RE: **Lot 21 Block 8 Volcano Cliffs Unit 22 SAD 228**
6308 Alderete Ct. NW
Grading and Drainage Plan
Engineers Stamp Date: 9/19/2023 (D10D003E21)
Pad Certification Date: 1/16/2024

DRAINAGE AND TRANSPORTATION INFORMATION SHEET

DATE	REVISION
LOT 21, BLOCK 8, VOLCANO CLIFFS, UNIT 22 ALBUQUERQUE, BERNALILLO COUNTY, NM	6308 ALDERETE CT, NW Grading & Drainage Plan

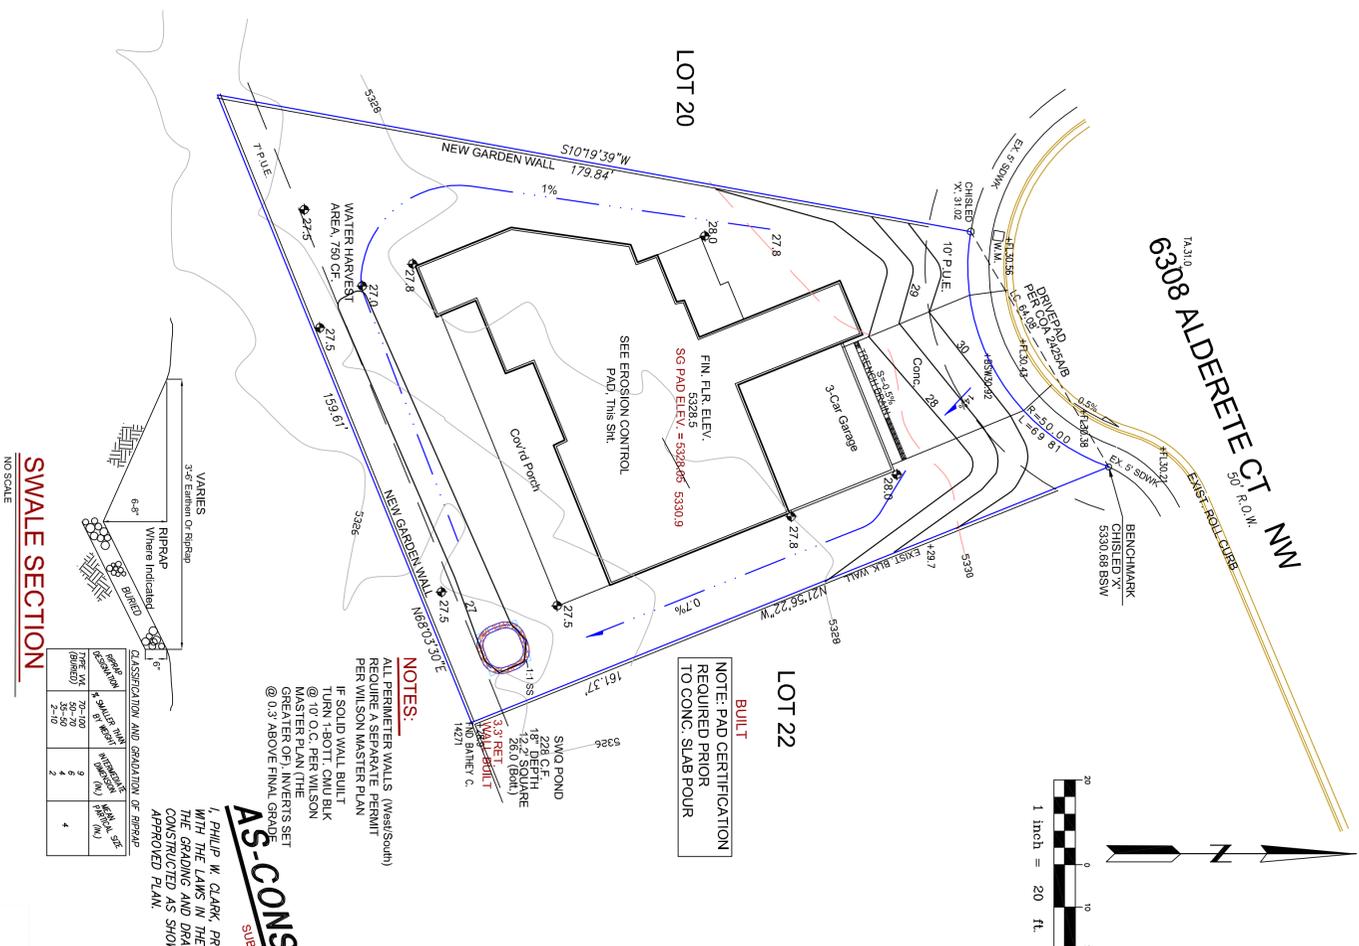
Advise the owner contractor not to use dirt as a ramp to climb the curb, use lumber or crusher fines for this purpose. Place this note on the plan.

Reiterate to the Owner/Contractor that a separate permit for a garden/retaining wall must be obtained with the approved G&D plan and Pad Certification. Also, if a swimming pool is to be placed after this approval a new grading and drainage plan will need to be resubmitted showing the changes for the land treatments.
